## Determination 2017/057

# Regarding the refusal to issue a code compliance certificate for a 20-year-old house with EIFS wall cladding at 15 Goldrush Lane, Rolleston

**Figure 1: Approximate plan**

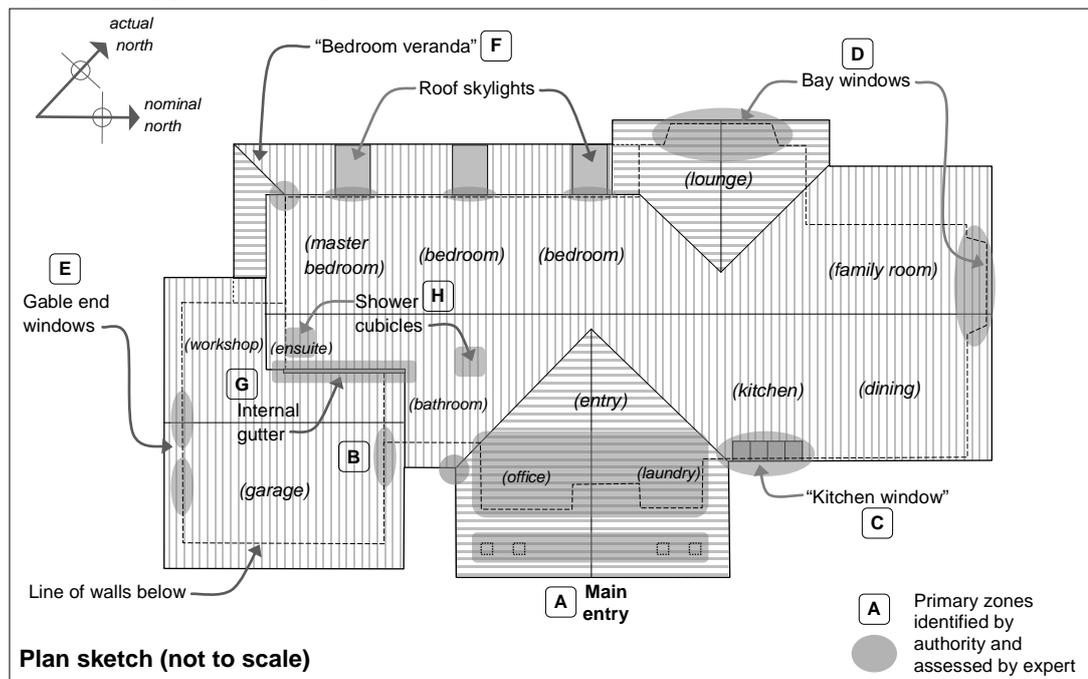
5.4.2 **Zone A:** Cladding clearances at the main entry (Items 2 to 4).

- EIFS was removed up to about 500mm above the paving (photographs show posts supported on steel brackets with a gap under the timber) and the schist veneer is installed over a drained cavity, with weep holes provided in the bottom course on each side of the stone plinths.
- EIFS was also removed from the base to the walls, with schist cladding and a drainage channel installed which discharges onto the ground at each end.

5.4.3 **Zone B:** The bottom of apron flashing at the north garage wall (Items 5 to 7):

- Although a proprietary uPVC diverter has been installed to the bottom of the flashing and the gutter now clears the plaster, there are still very high moisture levels in the adjacent framing, and the removal of lining from the garage wall revealed advanced decay in the bottom plate.
- The decay to the bottom plate appeared well established and the junction is likely to have leaked within the first 15 years after construction, with the framing around Zone B requiring ‘substantial reconstruction including replacing decayed framing’.

5.4.4 **Zone C:** The kitchen window (Items 8 to 11, 28 to 36):

- New flashings have been installed and glazing seals have been replaced, with open joints in the aluminium joinery unit filled with sealant, which is exposed to UV and likely to deteriorate prematurely – the joints probably resulted from seismic movement and should have been attended to during earthquake repairs.

5.4.5 **Zones D:** The bay windows (Items 12 to 16, 23 to 27):

5.4.6 **Zone E:** The gable end windows (Items 17 and 18):

- Apart from the bay windows, no windows include head flashings and high moisture levels were recorded below the garage south windows.

5.4.7 **Zone F:** The bedroom veranda (Items 37 to 47):

5.4.8 **Zone G:** The internal gutter (Items 54 to 61):
